Planning Commission Vote Report

Meeting Date: September 12th, 2022

Description: P.Z. 08-2022 TSG Chesterfield Airport Road (Stock & Associates Consulting Engineers Inc.): A request for a zoning map amendment from a "PC" Planned Commercial District to a new "PC" Planned Commercial District for 13 acres located north of Chesterfield Airport Road.

Figure 3: Preliminary Development Plan

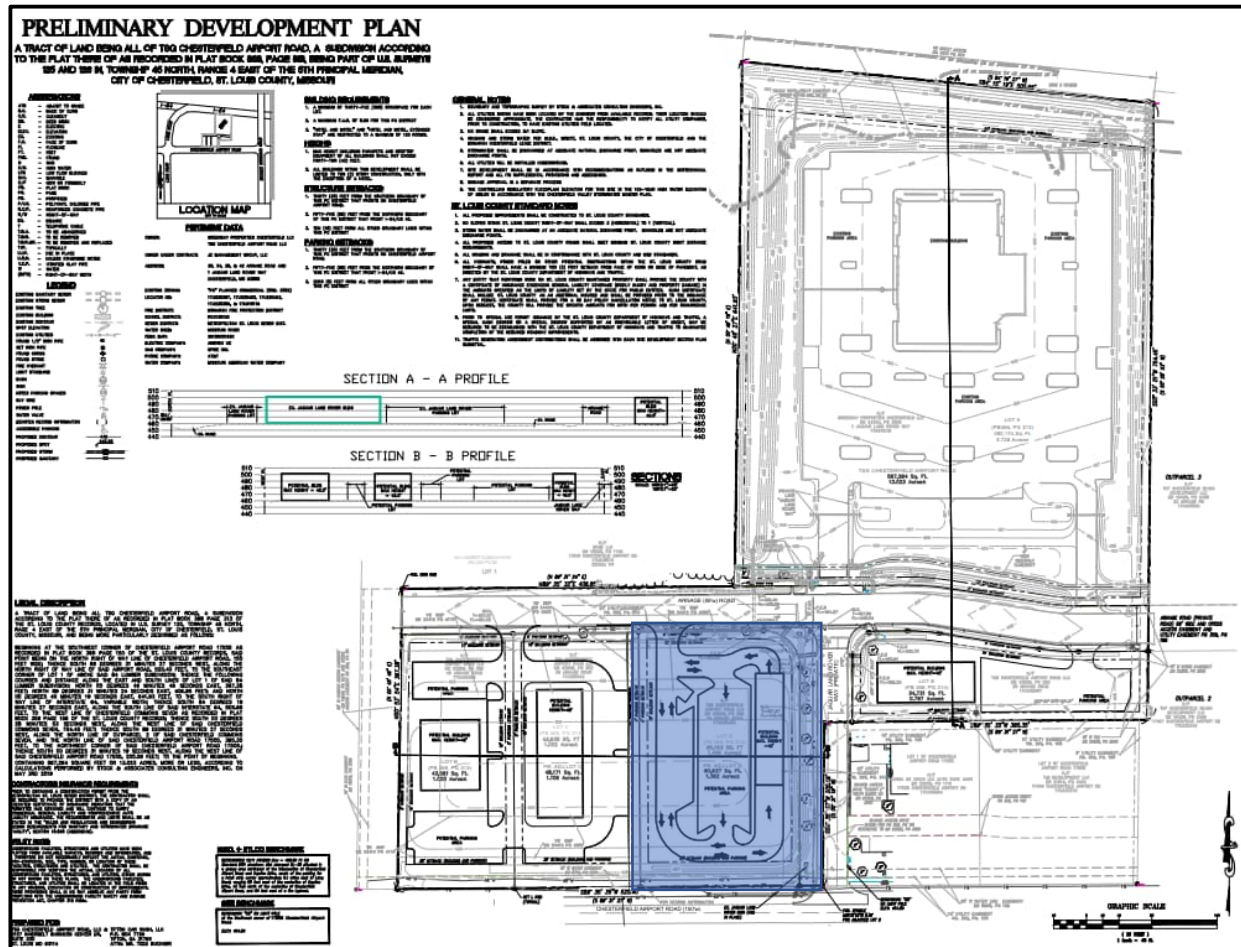
A zoning map amendment to a planned zoning district requires a Preliminary Development Plan, which has been included in the Planning Commission's packet. The blue shading in the figure below indicates the proposed location for the car wash.

A public hearing was held on August 22nd, 2022 at which time the Planning Commission and general public discussed the zoning map amendment. Planning Commission made the request that the petitioner review the existing permitted uses and determine if any could be removed. Since the Public Hearing, the petitioner has requested the removal of the following twelve (12) permitted uses: Art gallery, Art studio, Banquet facility, Check cashing facility, Church and other places of worship, Community center, Dry-cleaning establishment, Dry-cleaning establishment, with drive-through, Hotel and motel, Hotel and motel (extended stay), Specialized private school, Theater, indoor. The full list of the forty (40) existing permitted uses in Ordinance 3082 may be found on the following page.

Response: Sidewalk added to the Preliminary Plan.
